ADDENDUM NUMBER THREE

10 November 2025

NC Department of Natural and Cultural Resources
Fort Fisher Aquarium – Renovation & Expansion
Phase 1
SCO ID #17-18042-02A

LS3.61

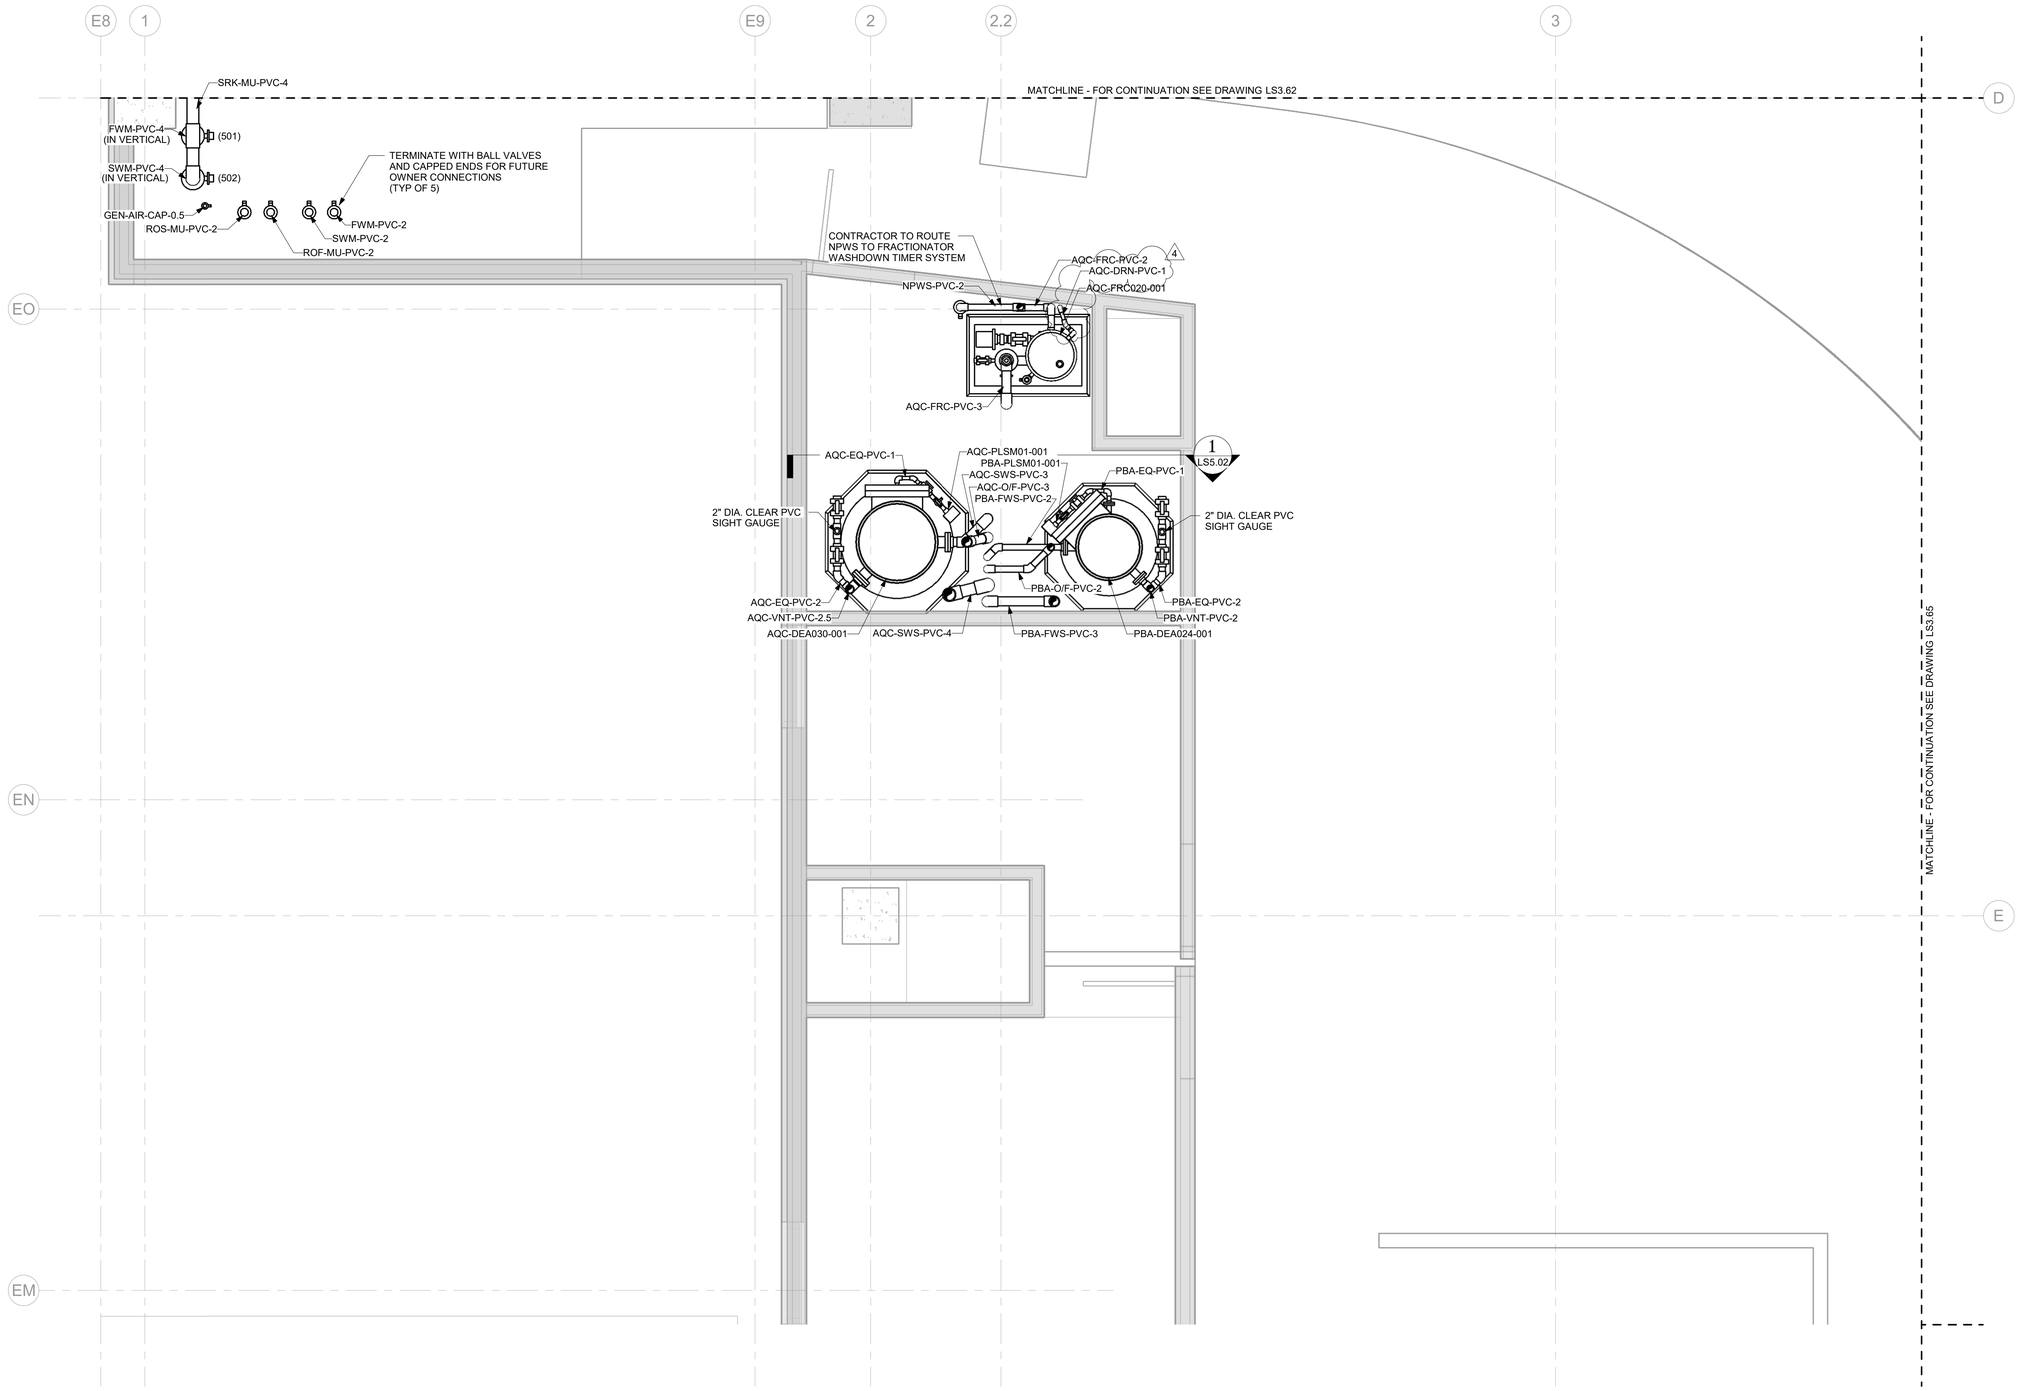
141. LS3.61: ENLARGED LSS PLAN - 3RD FLOOR - EL. 34.78' TO 41.73'
   a. Routed water softener backwash drain piping to plumbing's floor sink on 3rd level.

LS3.64

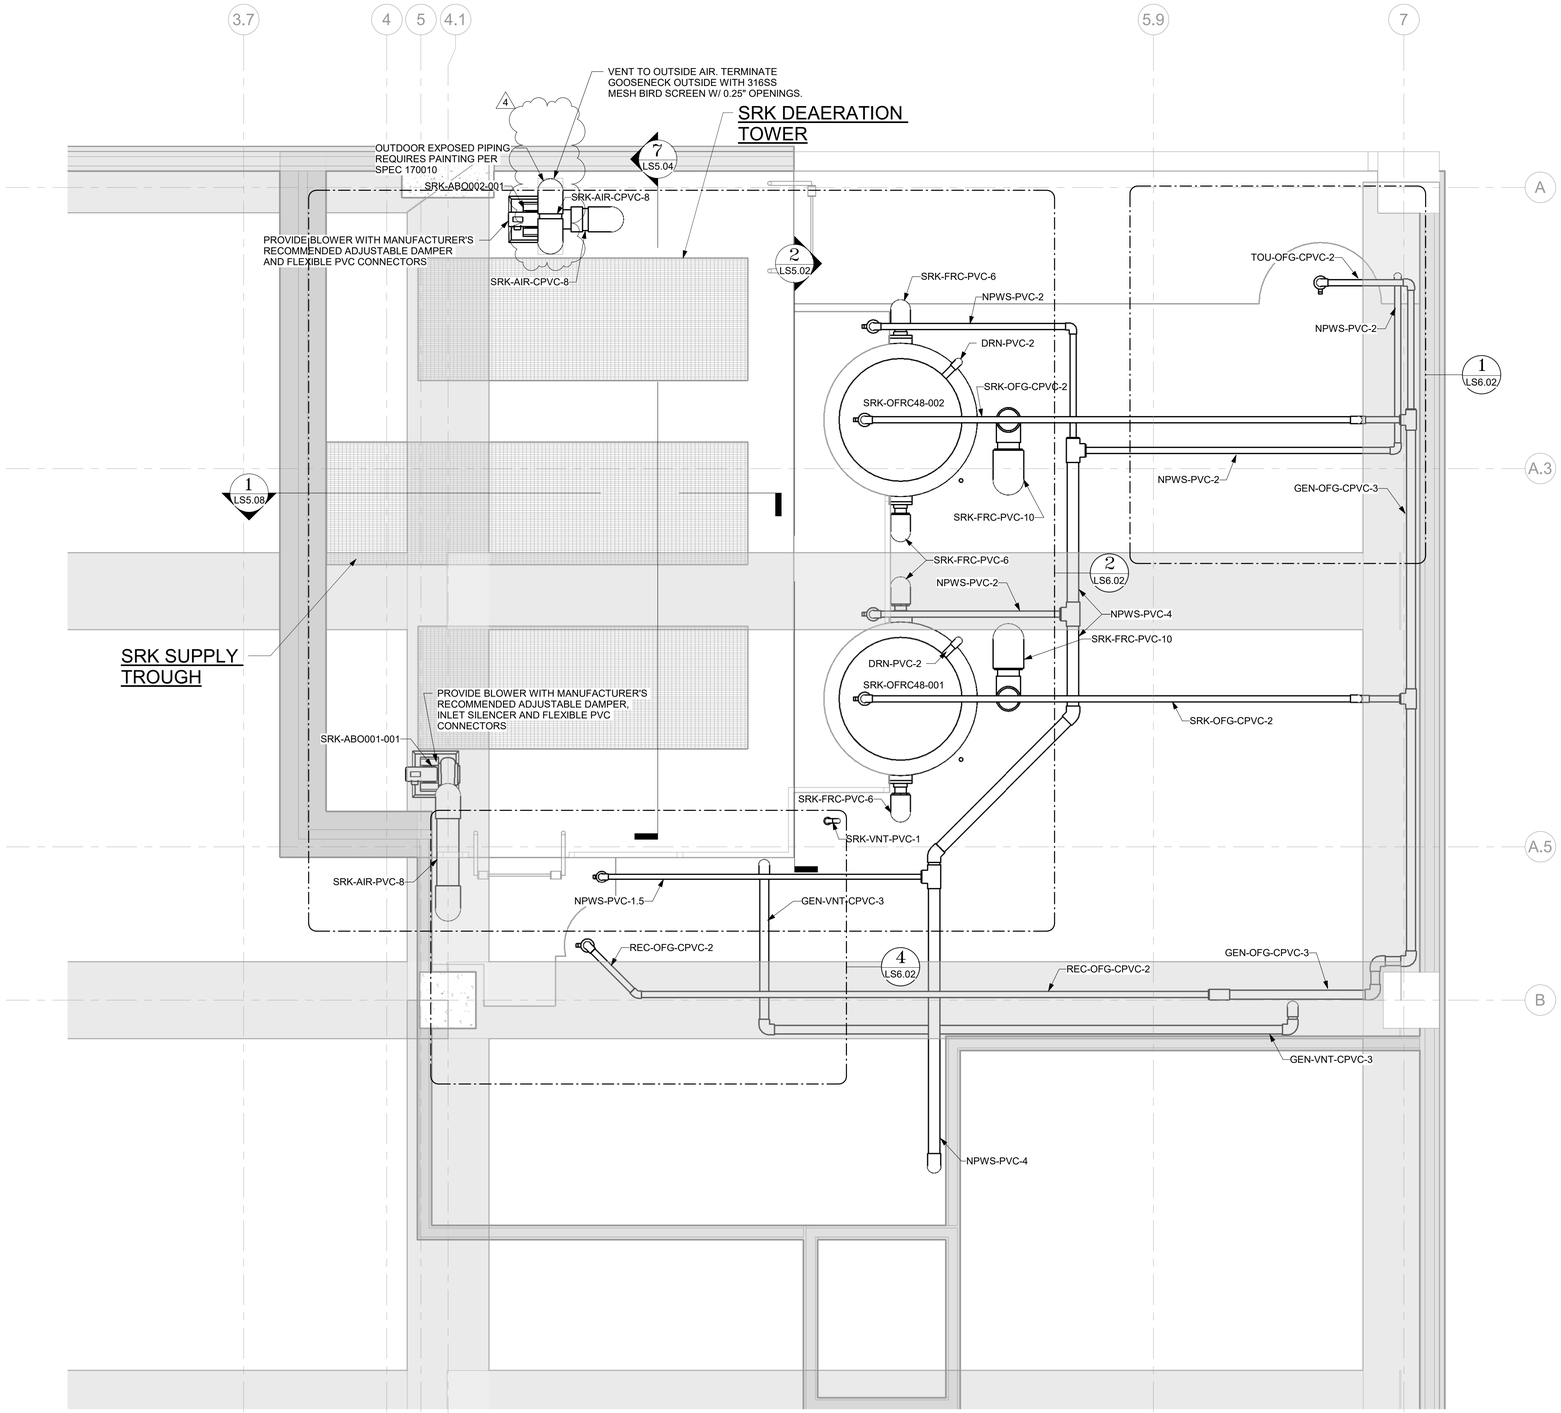
142. LS3.64: ENLARGED LSS PLAN - 3RD FLOOR - EL. 35.46' TO 45.96'
   a. Routed AQC frac drain to floor drain near PBA reservoir.
   b. Add pipe tag
